UNITED STATES PATENT AND TRADEMARK OFFICE

APPLICATION NO.	FILING DATE	FIRST NAMED INVENTOR	ATTORNEY DOCKET NO.	CONFIRMATION NO.
10/602,522	06/24/2003	James Yi	K0347.10U	2196

Office Action Summary	Application No. 10/602,522	Applicant(s) YI ET AL.	
	Examiner David Comstock	Art Unit 3733

DETAILED ACTION

Figure A

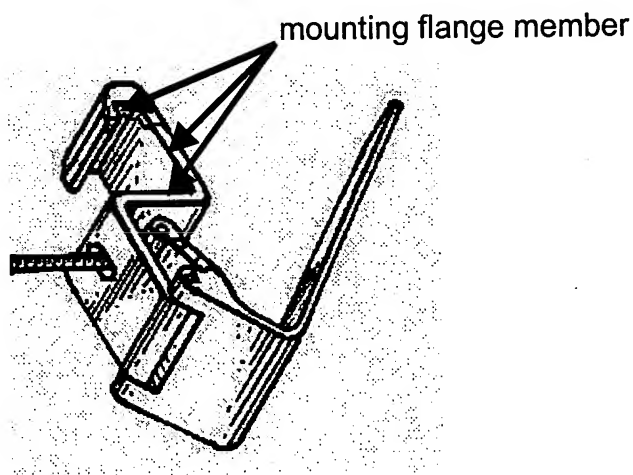
Koros et al. disclose a retractor device comprising a main body 28 having a generally C-shaped configuration comprising a foot member 54, an elevation wall member 44, 46, a mounting flange member, and a pair of extended hook members 38 mounted to the flange member (see Figures 1 and 5 and supplemental Figure A below).

Figure B

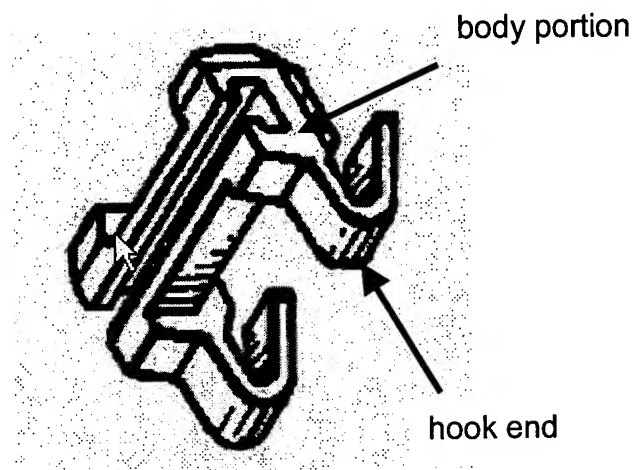
The elevation wall member 44, 46 comprises an upper wall member 44 joined to a lower wall member 46 along a radiused junction (see Figs. 5 and 7). The lower wall member is joined to the foot member and the upper wall member is joined to the flange member. The pair of extended hook members each comprise a hook end and a body portion (see, e.g., Fig. 5 and supplemental Figure B below).
